**STATE OF VERMONT
PUBLIC UTILITY COMMISSION**

Case No. 21-2939-NMP

NEIGHBOR INTERVENORS' MOTION FOR RECONSIDERATION

OF THE COMMISSION'S AUGUST 12, 2024 FINAL ORDER

From page 21 of Guidance For Agency Act 250 And Section 248 Comments Regarding Riparian Buffers: *[emphasis added]*

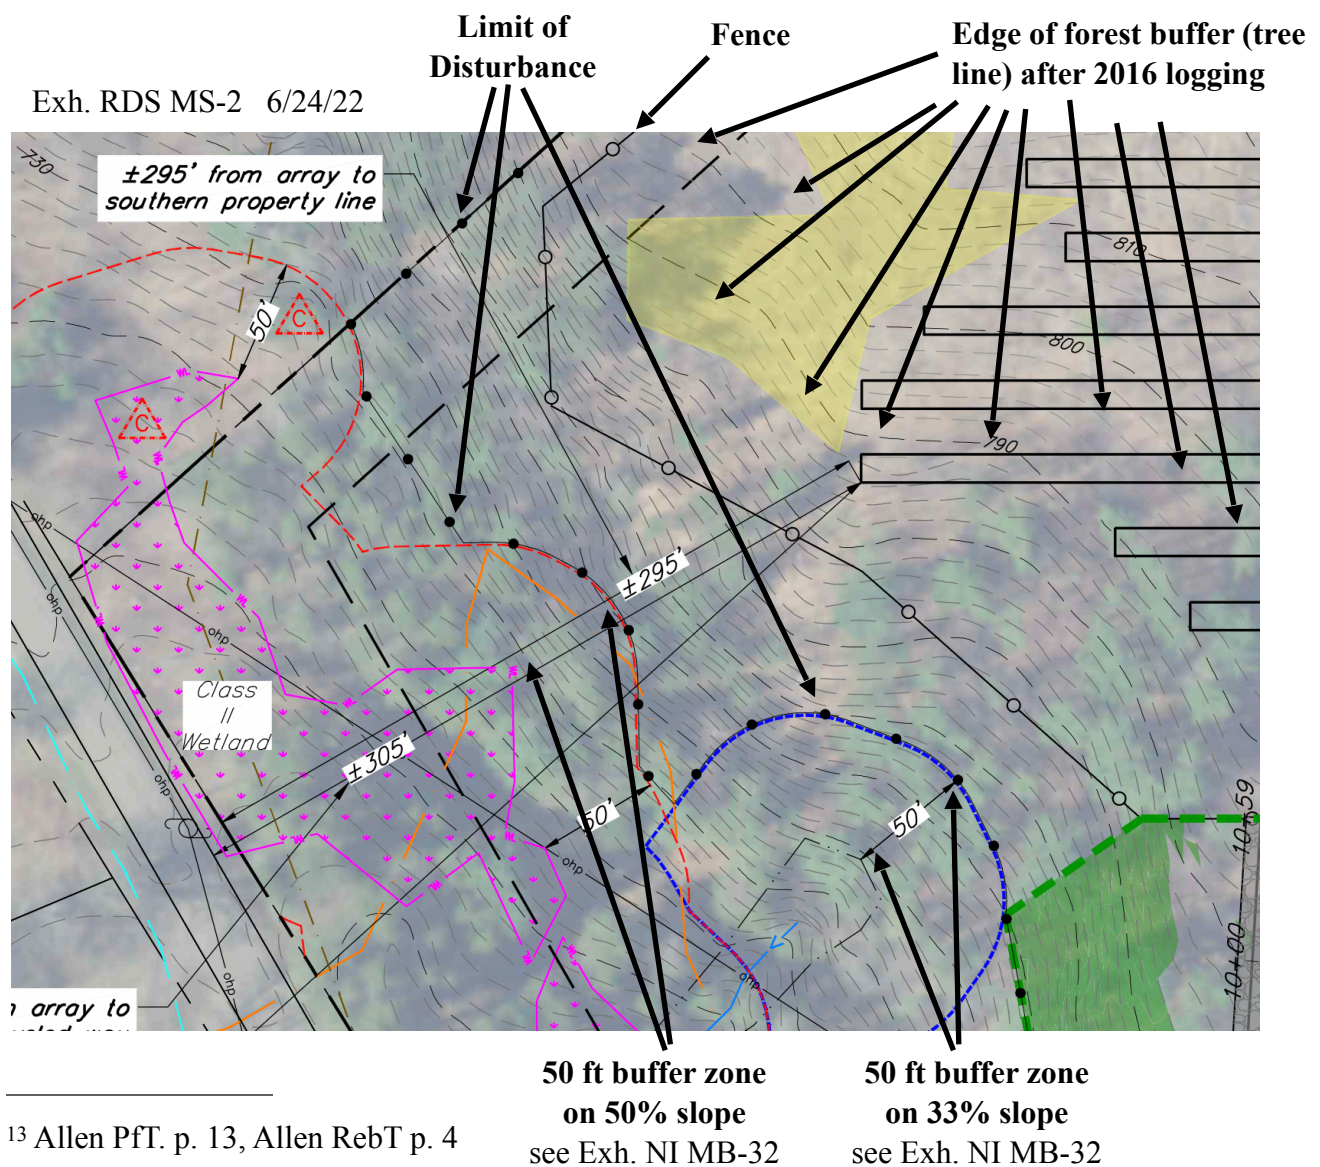
Riparian buffers filter stormwater runoff that flows through them as sheetflow. Buffer vegetation catches sediment and absorbs some of the nutrients and other pollutants contained in the runoff. Pollutant removal depends on the pollutant load and type, the composition and slope of the buffer, and the amount of runoff (Chase et al 1995). In general, to provide the same level of pollutant capture, **buffers in steep slope areas will need to be wider** as flows are typically faster moving and more concentrated.

AMPs have specified buffer widths depending on slope. For example, a 50% slope requires a 130 foot buffer.¹³ Regardless of whether or not AMPs apply here, the Commission should be certain that streams and wetlands are adequately buffered. The site was logged by Sam Lincoln in 2016 and Mr. Binder testified:¹⁴

The Commission should respect the 2016 wetland and stream buffers and not permit logging in the area between the limits of disturbance and the existing tree line; in which case the limits of disturbance should be moved to the existing tree line that was the 2016 buffer. The statutory **minimum** buffer for class 2 wetlands is 50 feet on flat terrain. No person can reasonably believe that the same 50 foot minimum buffer required on flat land is adequate on a 50% slope.

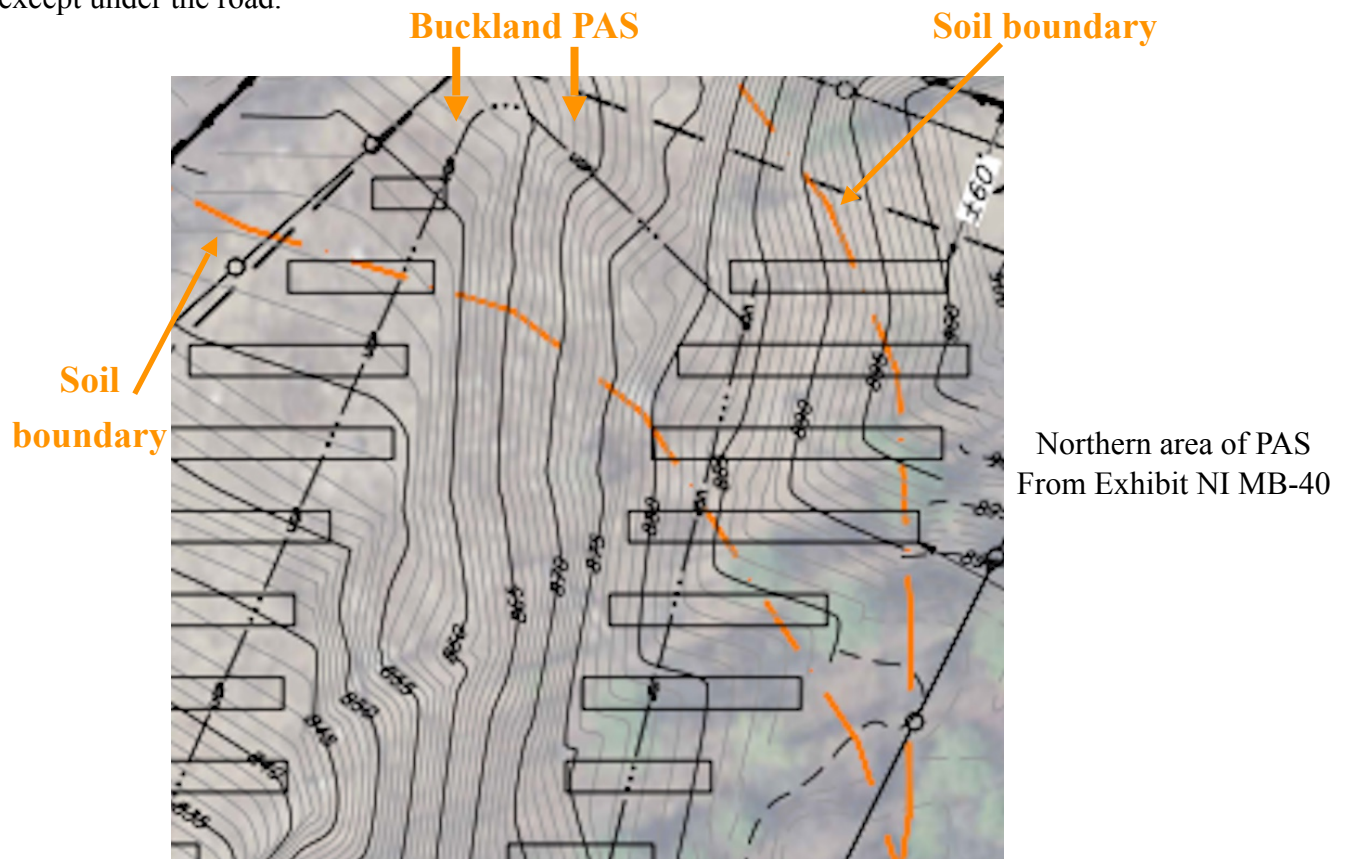
Rather than stockpiling PAS for reclamation, the Applicant intends to bury most of it up to 9 feet deep under a berm of non-PAS fill.¹⁸ No barrier (as required by AAFM's conditions) is specified in the site plan to separate the PAS from the fill.¹⁹ Even if the Applicant were to modify the site plan and specify a barrier between the PAS and the fill, the Intervenor has testified that the PAS cannot be meaningfully reclaimed at decommissioning after 25 years of anaerobic compaction under 9 feet of non-PAS fill.²⁰ No party has provided any testimony or evidence to the contrary.

The Commission's Rules permit applicants to make non-substantial modifications to their plans after approval, but that should only be done when the need for modifications was not foreseen during the application process. On Sept. 9, 2022 the Intervenor submitted testimony and an exhibit demonstrating that the stockpile was improperly sited.²¹ The Applicant has had two full years since then to amend their project, but has not done so.

The above mentioned violations of AAFM conditions are evident on the site plan. There is also a potential violation that is not seen on the site plan. The Commission should consider
